RE: Proposed 4 Lot Subdivision – Square 1 Building Associates
Tripp Hollow Road
Brooklyn, CT
Beecher Rd
CLA 6503

Attached are revised plans addressing engineering comments dated 9/5/20. Please note the following:

Drainage Calculations

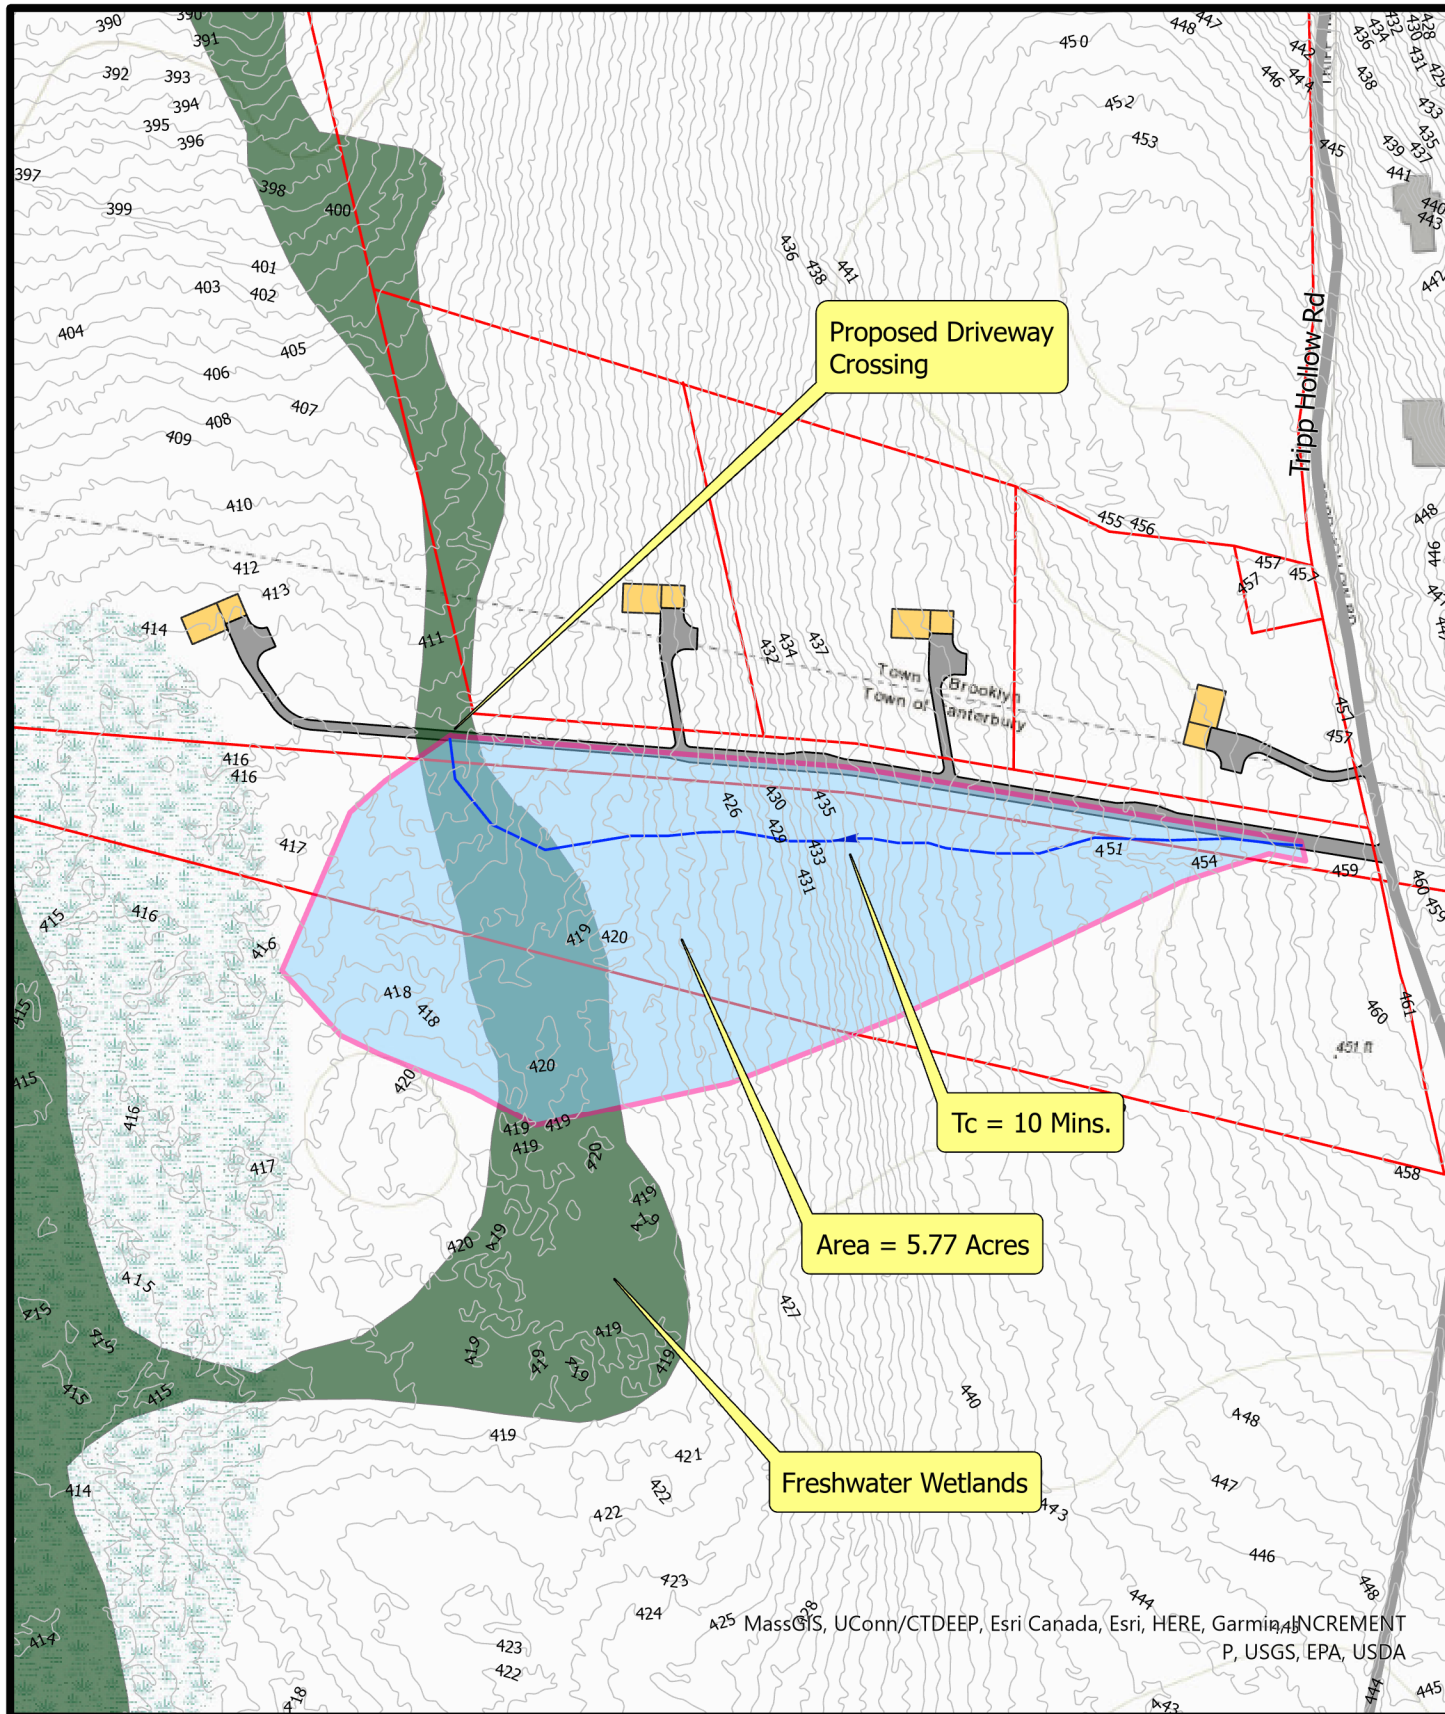
Calculations have been revised to account for 25-year storm.

Sheet 2 of 8

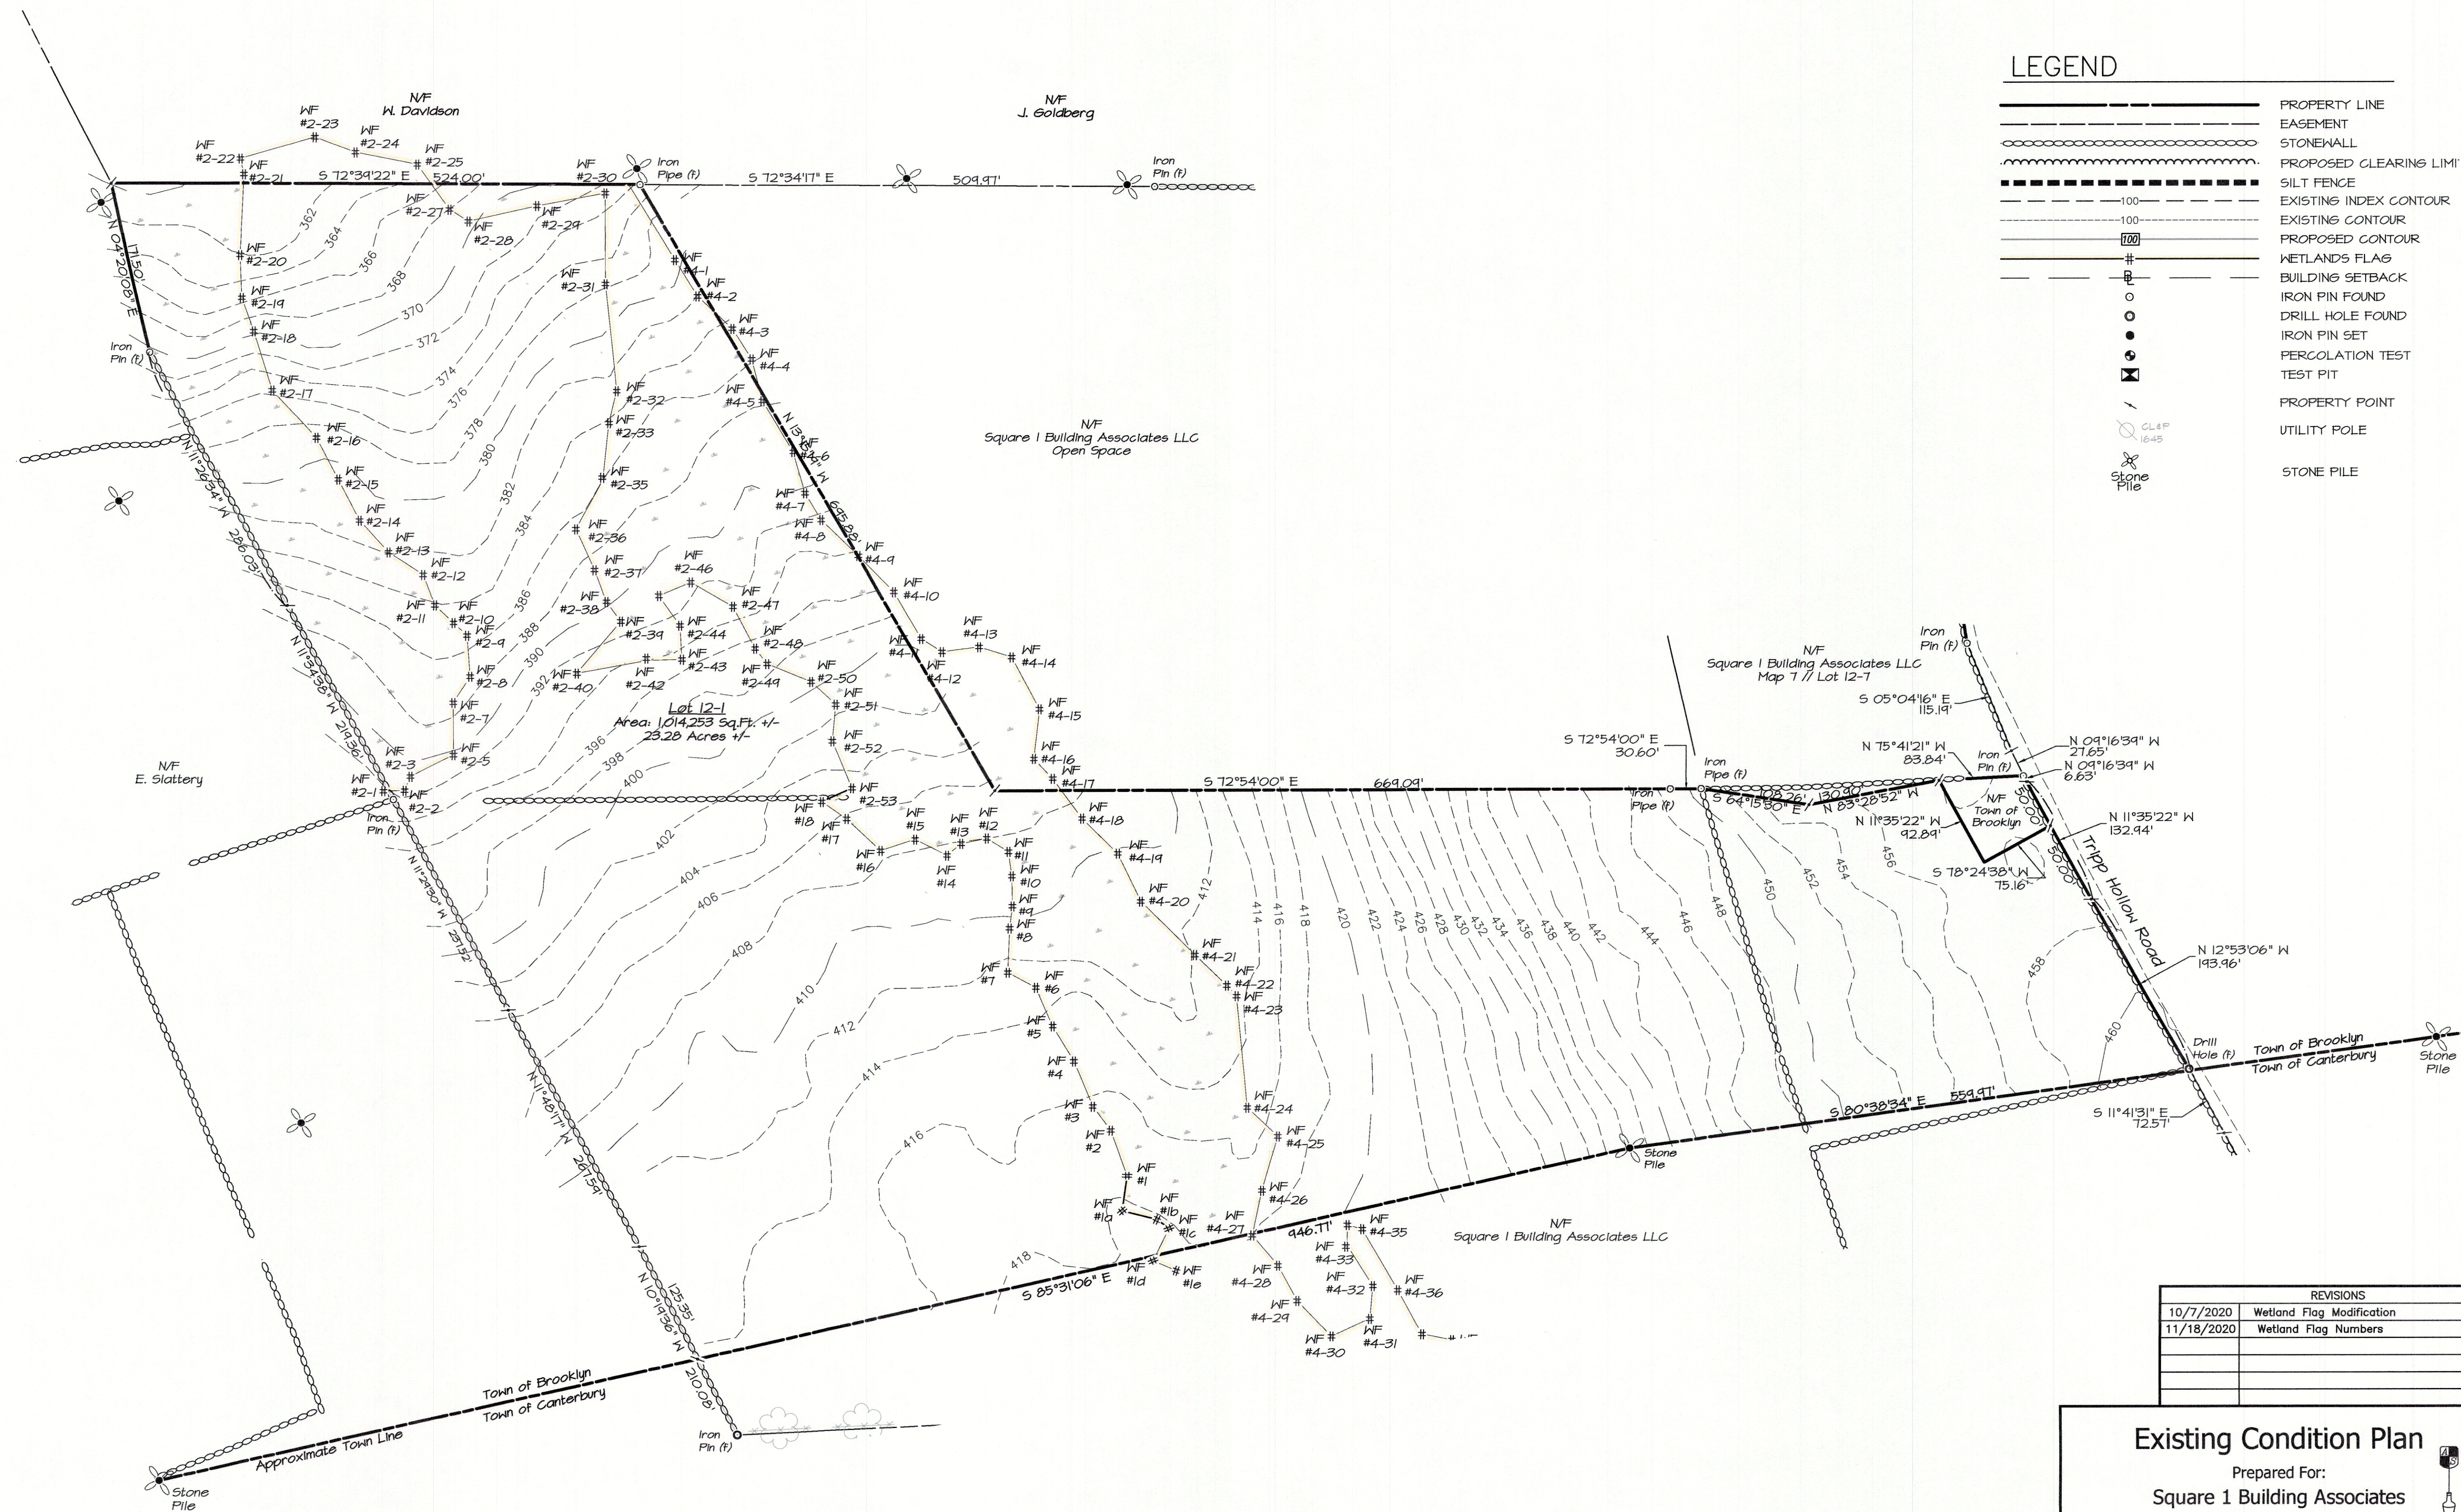
- 1) Signatures provided
- 2) Corrected
- 3) Corrected
- 4) Corrected
- 5) Corrected
- 6) Provided
- 7) Provided

Sheet 3 of 8

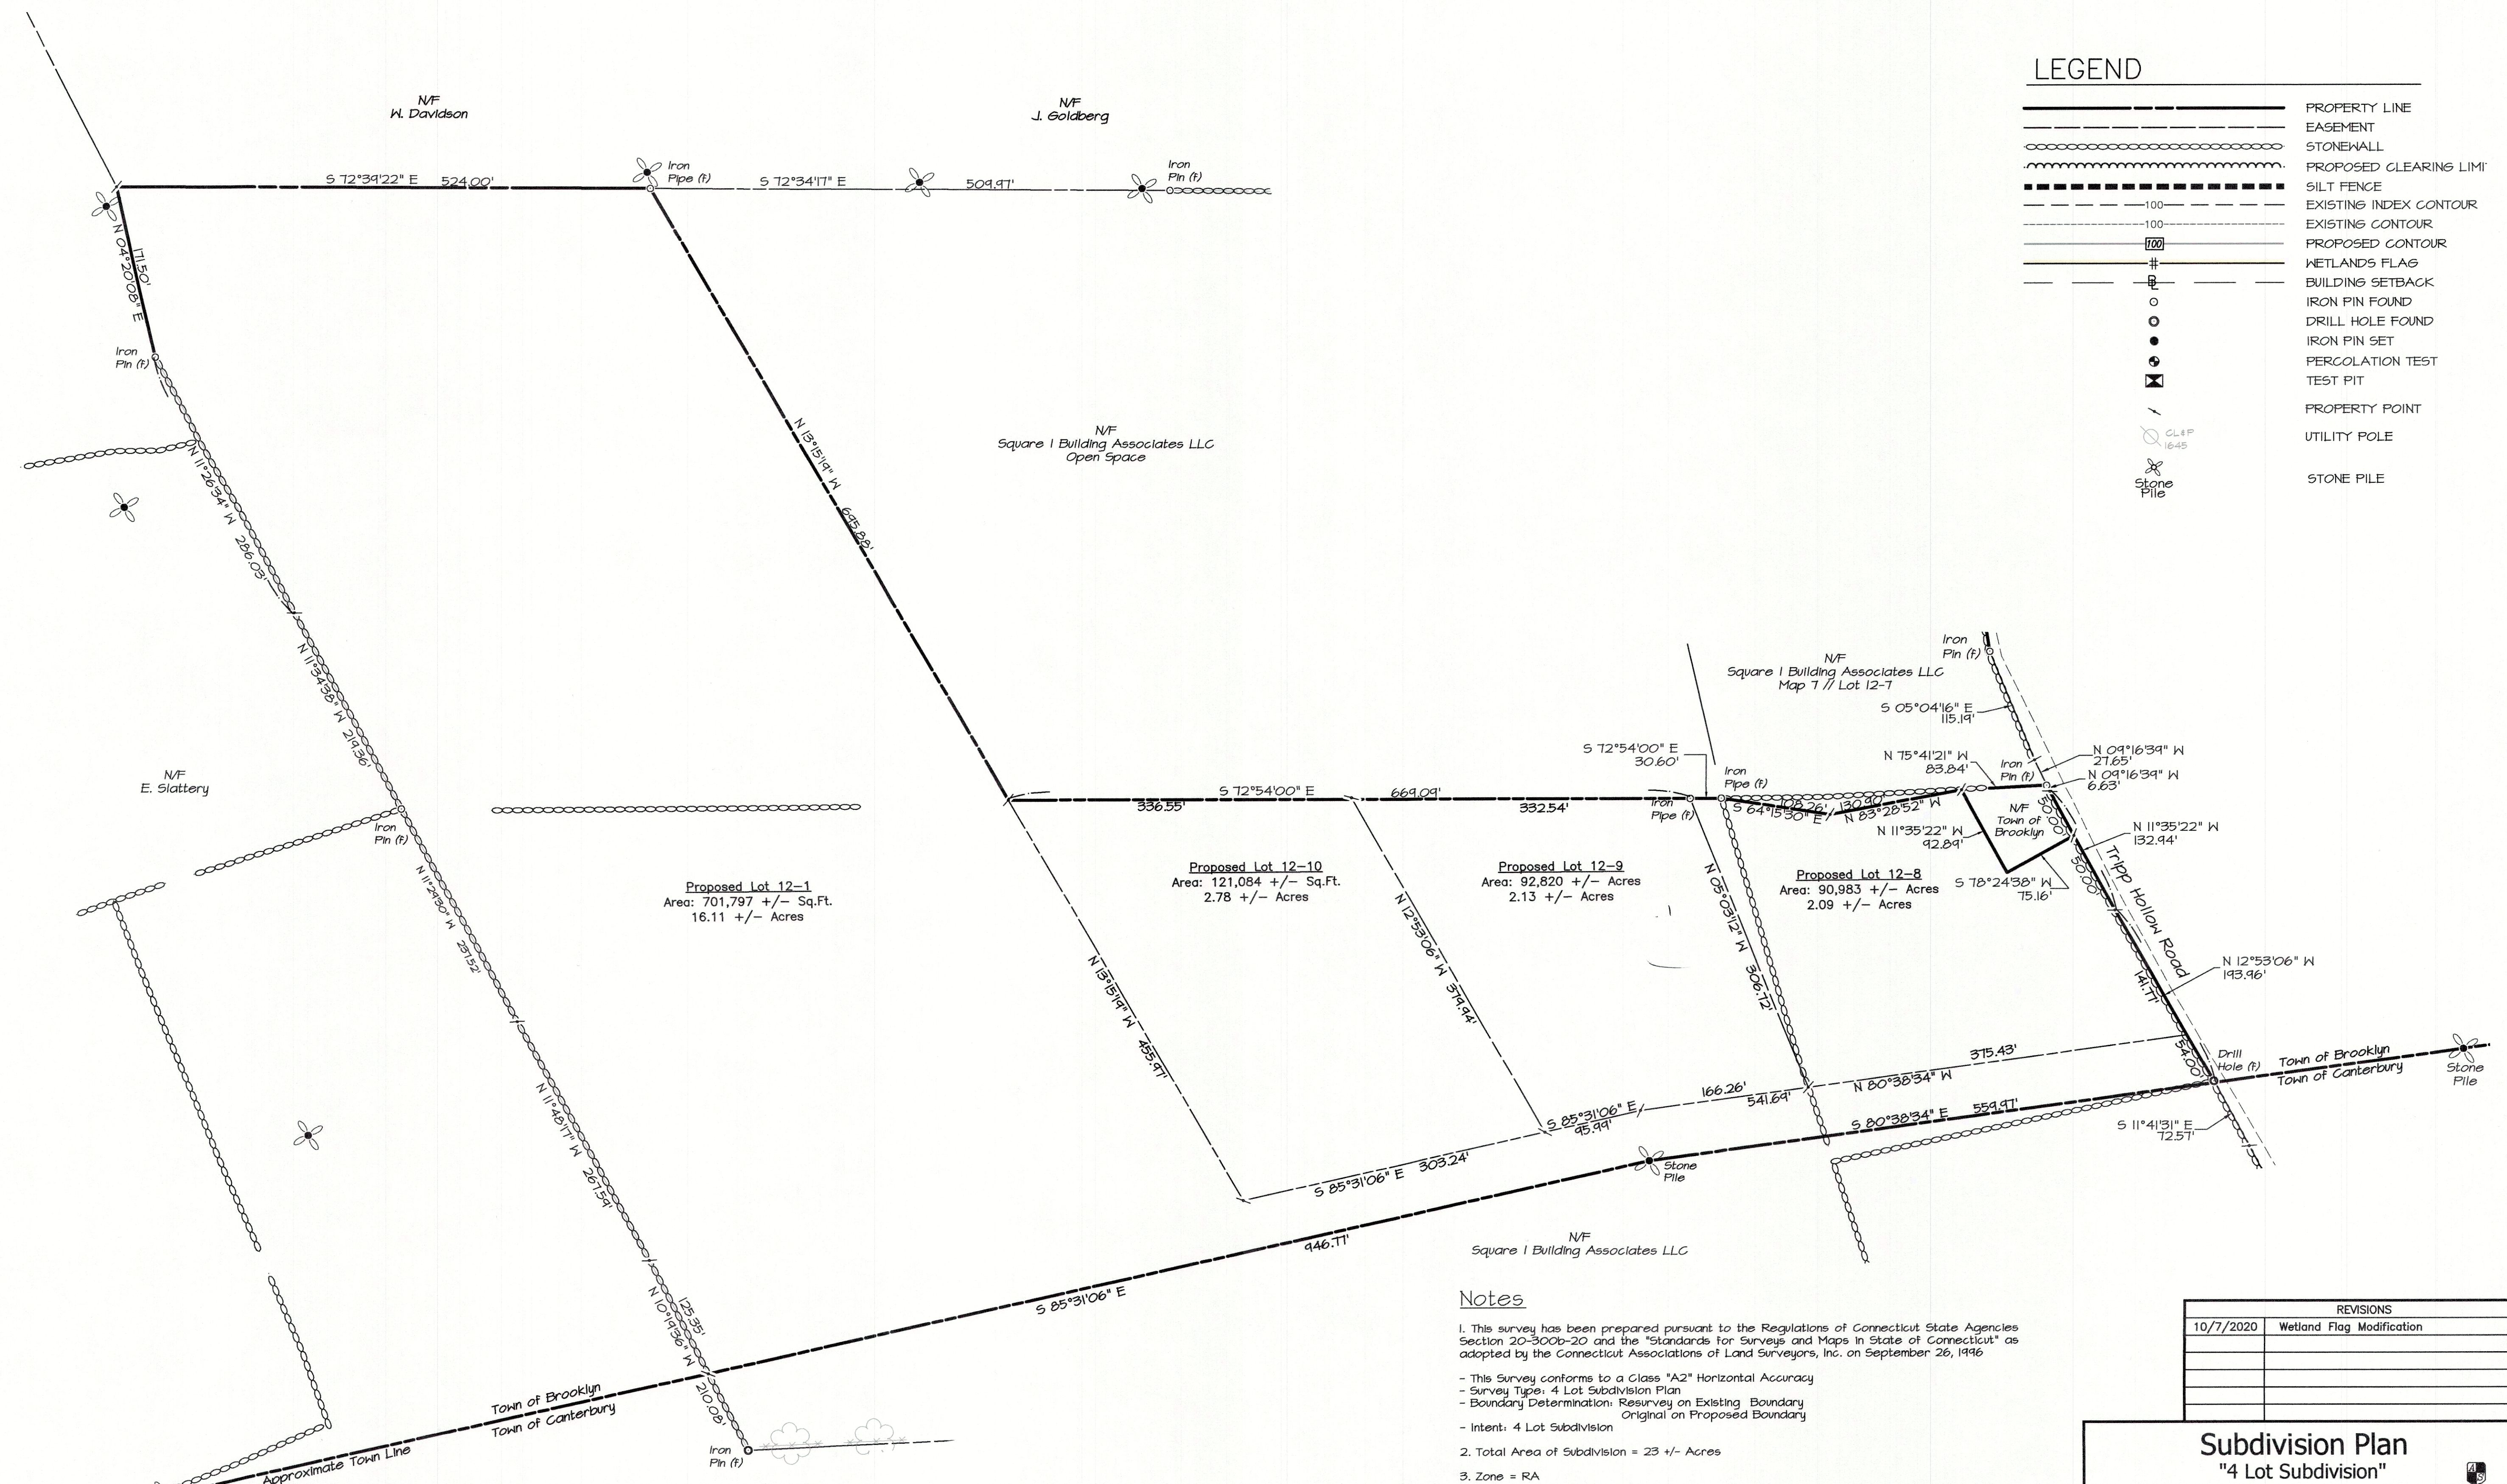
- 1) Addressed previously
- 2) Corrected
- 3) The land surveyor has stated that the Town did not require this for the recent adjacent subdivision to the North on the same unimproved Town Road. Town to clarify the need for this as it relates to consistency with the adjacent property.
- 4) Addressed previously
